SUPPLEMENTAL APPLICATION VARIANCE FROM ROADS/DRAINAGE STANDARDS

We are requesting a variance from Thurston County Road Standards Grand Mound Minor Collector and Local Roadways Standard 16A. We are submitting a request for approval of custom detail.

cross section for existing home area where reduced setback is requested

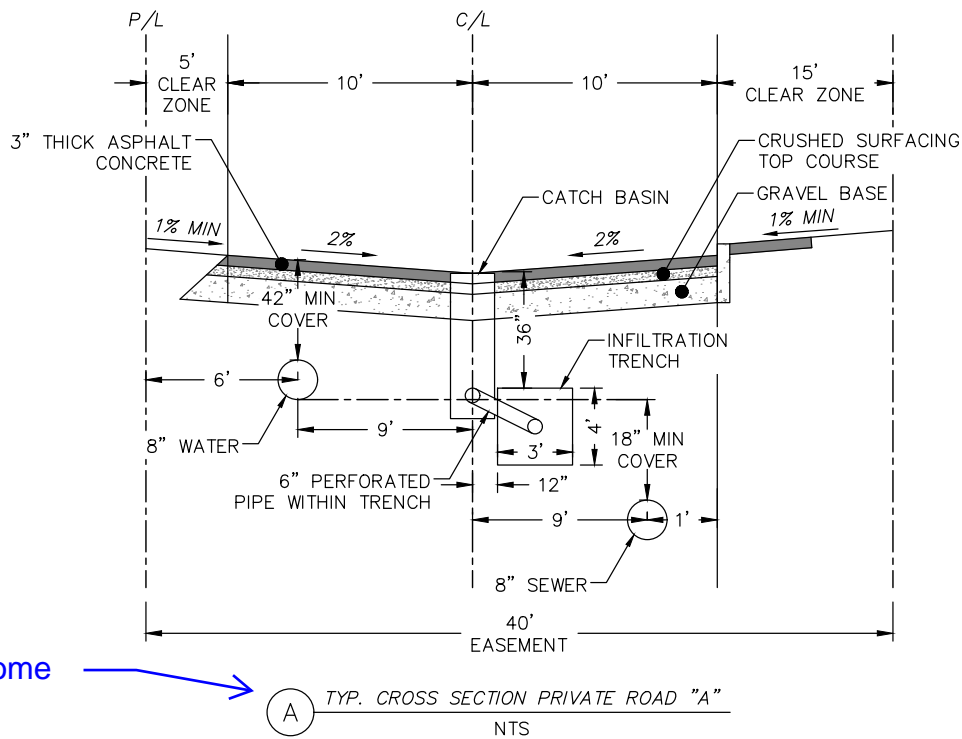
Based on this projects pre-submission meeting notes, we are required to follow road standards consistent with the Grand Mound UGA Minor Collector and Local Roadway Standard 16A. The intent of the Grand Mound road standards is to be public roads. This project proposes a private roadway adjacent to the existing homes which already have access to Tamarack Dr. This road also travels by an existing home which is 34 feet away from the neighboring property line. To accommodate the location of the existing home, the turn radius required to turn onto Tamarack Dr, as well as the width of the existing parcel, we are requesting a variance from Roadway Standard 16A to a custom detail as shown on the civil construction plans. Also a custom cross section exhibit has been included in this application for quick access. The major differences between this custom road section and road standard 16A are:

- 1.) Curb, gutter and sidewalk to follow along the west side of the development only. We are requesting a variance from the 16A standard which requires curb, gutter and sidewalk on both sides of the roadway.
- 2.) The Grand Mound Road Standards requires a planter strip between the curb and sidewalk. This development is requesting a private road to be maintained by an HOA. No through traffic is expected and will be designated to local only. The custom detail we are requesting does not have a planter strip.
- 3.) Standard 16A requires each lane of traffic be 11ft wide. We are requesting a variance to each lane of traffic to 10 ft as shown in the custom detail.

The custom detail we are submitting is for a private roadway local access only. The custom detail will show we are providing full pedestrian access along the west side of the roadway. Entrances are provided at both ends of the development of the two lane roadway at both 198th Ave and Tamarack Dr for safe access for emergency services to enter and exit. You will find fire hydrants are accessible within a 400 ft radius of the development at both Tamarack Dr and 198th Ave. The roadway is to be paved as to Standard 16A and is designed with an inverted crown for appropriate drainage purposes.

4.) Roadway standard 16A shows a 50 ft easement. Shown per the site plan, we are requesting a variance to a 40 ft easement through the length of the roadway excluding along the existing garage shown on lot 1 where we are showing a 30 ft easement for 24 ft to accommodate the pre-existing structure that is to remain.

The main reason for request is to protect the existing structure and work within the existing property boundaries of the parcel. Without approval of the variance the existing structure would need to be demolished.
